**SRR-CWDA-2013-00087**  
**Revision 0**

**FY2013 Special Analysis for the Saltstone  
Disposal Facility at the Savannah River Site:  
Quality Assurance Report**

**June 2013**

Prepared by: Savannah River Remediation LLC  
Closure & Waste Disposal Authority  
Aiken, SC 29808

Figure 7.2-1: Comparison of 100-Meter MOP Dose Results, Corrected versus Uncorrected

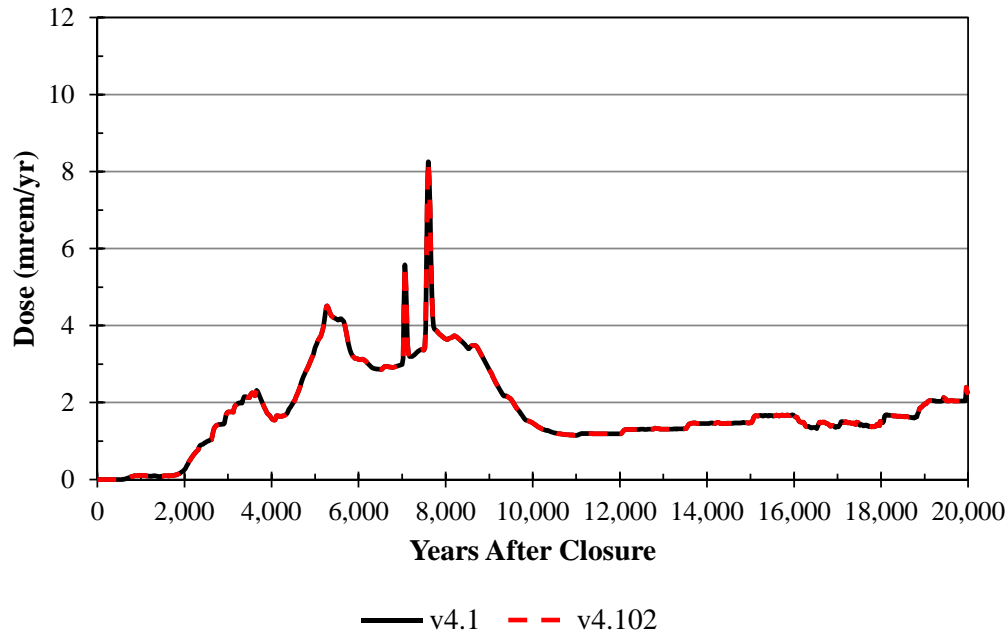
It was determined during checking that all the dose calculations performed in support of the SDF SA used a set of soil-to-plant ratios that was inconsistent from the values recommended in the referenced report *Dose Calculation Methodology for Liquid Waste Performance Assessments at the Savannah River Site*. [SRR-CWDA-2013-00058] The values that were used in the SDF SA came from a superseded, draft iteration of the data set that had been developed for the reference dose calculation report. Table 7.2-1 provides a comparison of the values that were used in the SDF SA versus the recommended values. As shown, the SDF SA applied slightly higher (i.e., conservative) soil-to-plant ratios.

The dose calculations in the SDF SA used 0.2 hrs/day (i.e., a fractional value of 0.0083). This value reflects an average value provided by the U.S. Environmental Protection Agency (EPA), i.e., the average person spends 0.2 hrs/day performing lawn and garden care. [EPA-600-R-090-052F] However, this average value includes the 69% of households that do not have any gardens. The referenced dose calculation report recommended modifying this value to conservatively assume that *all* Members of the Public (MOP) and Inadvertent Human Intruder (IHI) receptors have gardens ( $0.0083 \div 0.31 = 0.027$ ). [SRR-CWDA-2013-00058] In summary, the SDF SA used the average value rather than the recommended value based on a conservative assumption.

A detailed evaluation was performed to disposition these irregularities. For this investigation, a revised dose calculator model was developed (*SRS Saltstone v4.102\_20yr\_Det.gsm*) and was run using the same GoldSim<sup>®</sup> calculation described within the benchmarking discussion from Section 5.6.2 of the SDF SA. The MOP and IHI dose results from both the uncorrected and the corrected dose calculations were plotted (see Figures 7.2-1 and 7.2-2), showing that these irregularities had a minimal impact on the total dose results. These figures are comparable to Figures 5.6-23 and 5.6-36 of the SDF SA. Over the entire 20,000-year simulation period, the total MOP doses varied by only 2.0E-04 mrem/yr and the total IHI doses varied by only 1.0E-03 mrem/yr. This difference between the two models is four to five orders of magnitude smaller than the respective peak doses, thus these irregularities are considered negligible.

**Figure 7.2-3: Comparison of Probabilistic 100-Meter MOP Dose Results, Corrected versus Uncorrected**

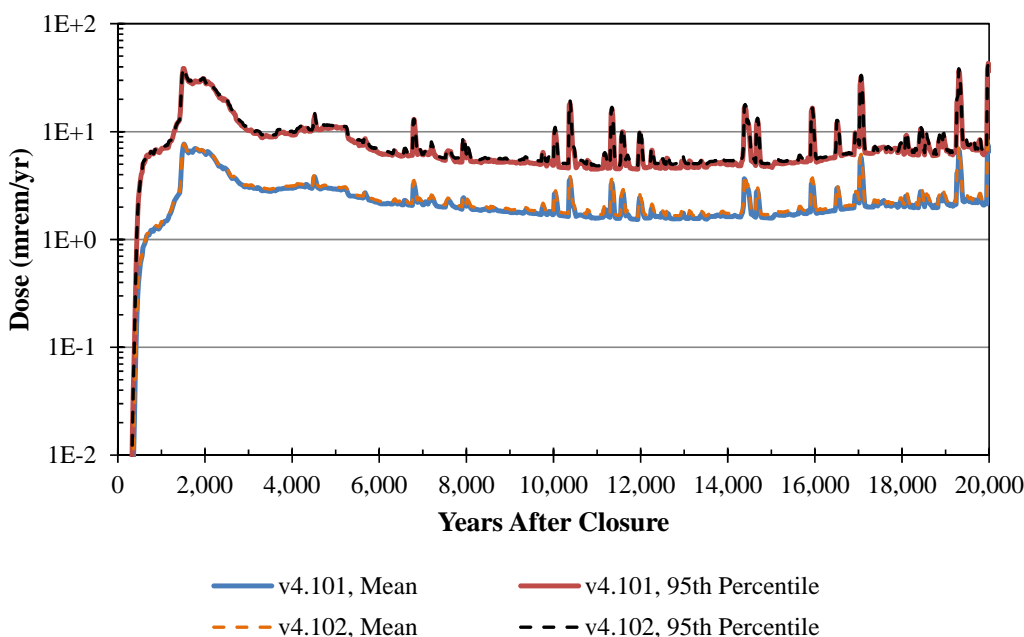
in earlier PA dose calculations, these values were not correlated. The dose calculation report also recommended truncating the sampled values of the surface density parameter, but this value was not truncated in the SDF SA. Finally, the bulk sandy soil density applied a standard deviation of  $100 \text{ kg/m}^3$ , whereas the dose calculation report recommended a standard deviation of  $120 \text{ kg/m}^3$ .

These irregularities only affected probabilistic modeling. Correcting these values would reduce variability in the sampling results for these parameters, but not significantly affect the statistical outcome of such sampling (e.g., the mean of the sampled value would not be significantly affected). Note that these parameters did not show up as being important during the sensitivity analyses in the SDF SA; therefore, reducing parameter variability is not expected to significantly affect the outcome. Thus, revising the uncertainty or sensitivity analyses is not necessary to evaluate this irregularity. Instead, a probabilistic model that incorporates corrections to all of the aforementioned irregularities was run for 1,000 realizations and the 95<sup>th</sup> percentile and the mean was compared to the equivalent dose results from the SA model file: *SRS Saltstone v4.101\_20yr\_RS01.gsm*, as described below.

A detailed evaluation was performed to disposition these irregularities. For this investigation, a revised dose calculator model was developed (*SRS Saltstone v4.102\_20yr\_RS01.gsm*) and was run using the same GoldSim<sup>®</sup> calculation as used in the Uncertainty Analysis discussion from Section 5.6.4 of the SDF SA (using a random seed of 1, the equivalent SDF SA model file is: *SRS Saltstone v4.101\_20yr\_RS01.gsm*). The MOP dose results from both the uncorrected and the corrected dose calculations were plotted (see Figures 7.2-3), showing that these irregularities had a minimal impact on the total dose results. This figure is comparable to Figure 5.6-40 of the SDF SA. In general, the doses increased between 1 % and 5 %. For example, the peak of the mean in 10,000 years was 7.66 mrem/yr in *SRS Saltstone v4.101\_20yr\_RS01.gsm* compared to 7.73 mrem/yr in *SRS Saltstone v4.102\_20yr\_RS01.gsm*. Given that the probabilistic model results between individual realizations can vary by orders of magnitude, this percentage increase is considered negligible.

Figure 7.3-1: Comparison of 100-Meter MOP Doses Using the Latest Soil  $K_d$ s for Iodine

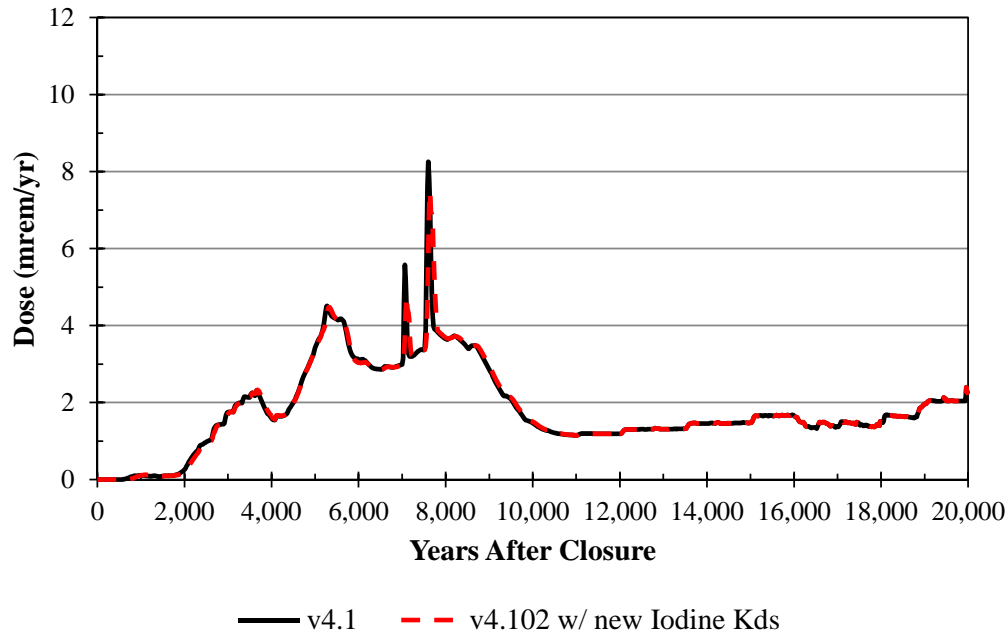
Upon completion of the initial draft of the SDF SA, a new technical report, *Radioiodine Geochemistry in the SRS Subsurface Environment*, was issued with revised site-specific iodine  $K_d$ s in SRS soils. [SRNL-STI-2012-00518] In sandy soils, the iodine  $K_d$  increased from 0.3 mL/g to 1.0 mL/g. Similarly, in clayey soils, the iodine  $K_d$  increased from 0.9 mL/g to 3.0 mL/g. By applying the cement leachate factors from Table 13 of SRNL-STI-2009-00473, the new leachate-impacted soils  $K_d$ s are 0.1 mL/g and 0.3 mL/g for sandy and clayey soils, respectively.

Although the change is likely to reduce the expected dose by retarding the transport of I-129, it is also possible that the new values could cause the I-129 dose peak to occur at the same time as one of the Tc-99 peaks, thus potentially resulting in a higher overall peak dose. Therefore, these new  $K_d$  values were evaluated using the model file *SRS Saltstone v4.102\_I\_Kd.gsm*.

Figures 7.3-1 and 7.3-2 show that the new  $K_d$  values have no adverse impact on the overall peak doses. The new  $K_d$  values do not significantly affect the timing of the peak doses, but does decrease the peak doses by about 10%. The peak MOP dose decreased from about 8.3 mrem/yr to about 7.5 mrem/yr and the peak IHI dose decreased from about 36 mrem/yr to about 33 mrem/yr. Therefore, the results discussed in the SDF SA may be considered conservative.
